# KwikStik-K40

## Hardware Errata

Rev. 3

## KWIKSTIK\_01: K40X256 MCU cannot be turned OFF using the ON/OFF switch

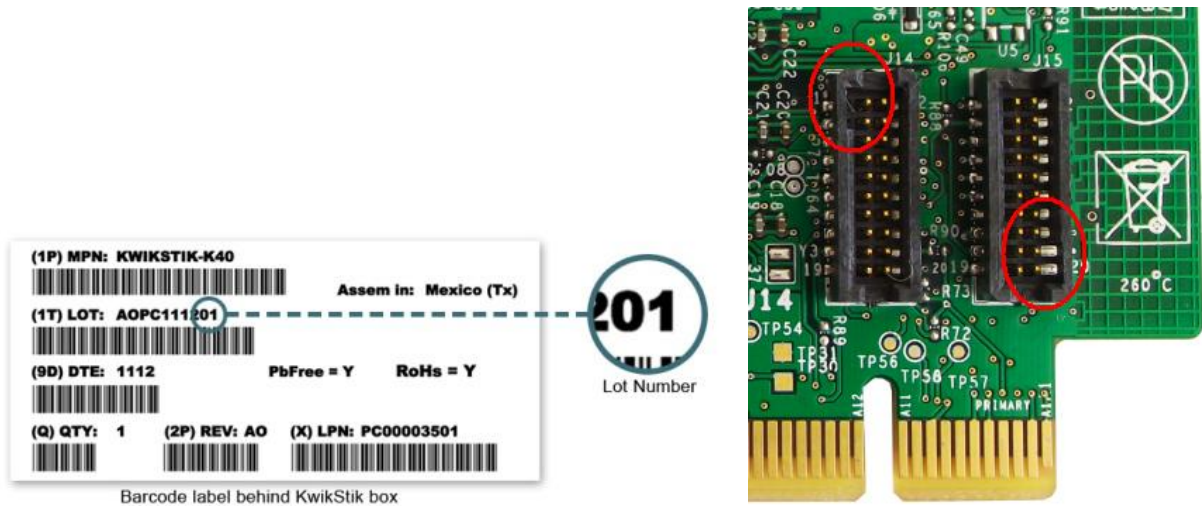
When the ON/OFF switch SW1 is in the OFF position, the K40 MCU is not turned off. This can cause unexpected behavior when trying to use the JTAG connector for external device programming and debugging.

Removing power supply to VREFH will allow the K40 to be switched off. To do so, remove ferrite F5.

This issue is fixed starting in version 4.

# KWIKSTIK\_02: TWRPI connectors populated in a wrong orientation

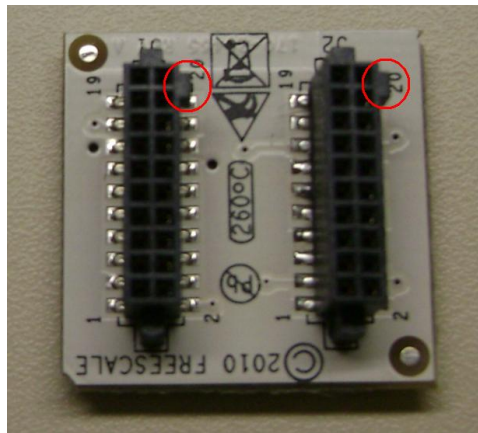
KWIKSTIK-K40 PWA Rev A/3.0 Boards of shipment lots 01-04 may have the TWRPI connectors (J14, J15) populated in a wrong orientation.

To use the TWRPI interface you will need to remove the key/notch from the female connectors of the TWRPI boards.

## **KWIKSTIK\_04: SD Card signals connected to incorrect pins**

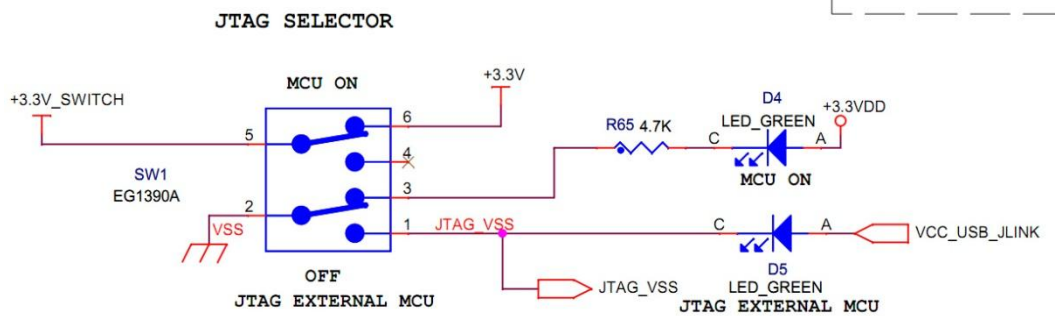
The SD card connector's data pins (DATA0-DATA3) are connected to SDHC0\_D4-SDHC0\_D7 which are unused in 4 bit mode.

No practical workaround is available.

This issue is fixed in version 5.

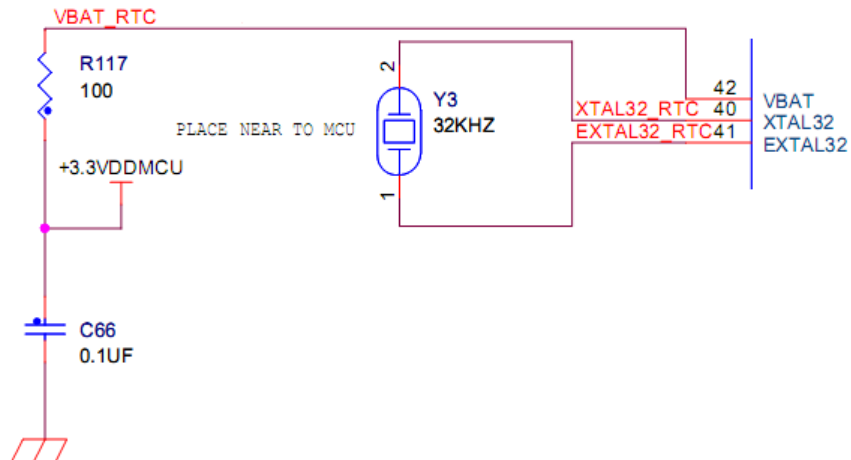
- 1) KWIKSTIK\_01 Errata was corrected. SW1 switch effectively powers down the K40 MCU

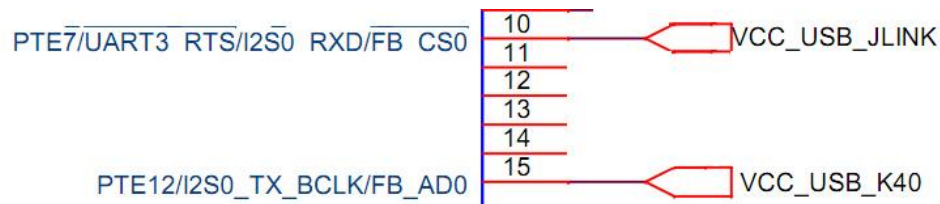
- 2) Added R117 and C66 connecting the RTC VBAT (K40X256 pin 42) to the 3.3V MCU supply.
